# RECOMMENDED SERVICE BULLETIN

## RSB 42-102

Inspection for insufficient clearance between the canopy arms and the resistors of the ice lights in the instrument panel.

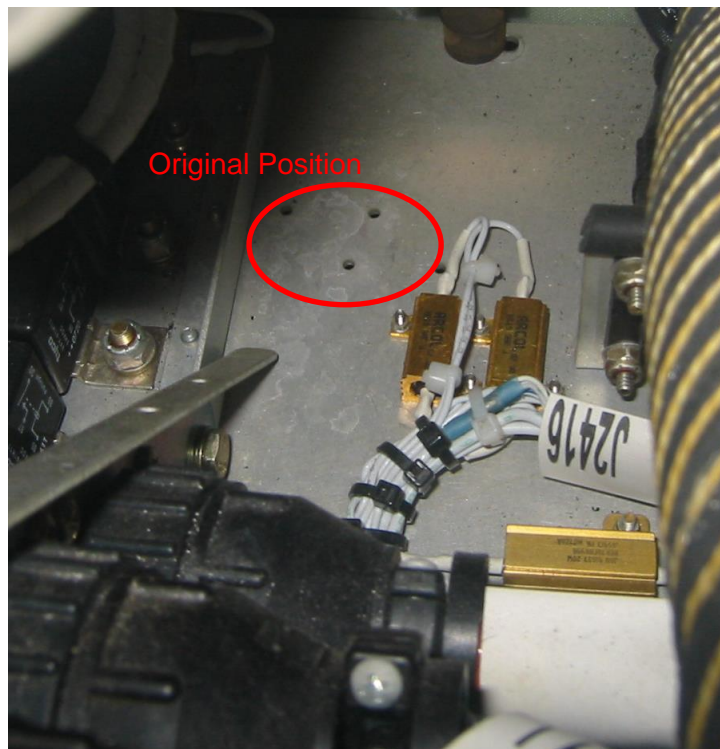
Inspect the resistors of the ice lights (position shown on the photograph) for sign of collision or contact with the canopy arm (such as chafing or dents).

Determine the minimal clearance between the resistors and the canopy arm with the canopy in the closed position.

If there are signs of contact or collision, inspect the canopy arm for chafing and deformation.

If there are signs of contact or collision or if the minimal clearance is less than 2 mm, install the two resistors 30 mm aft and 25 mm to the right from the original position.
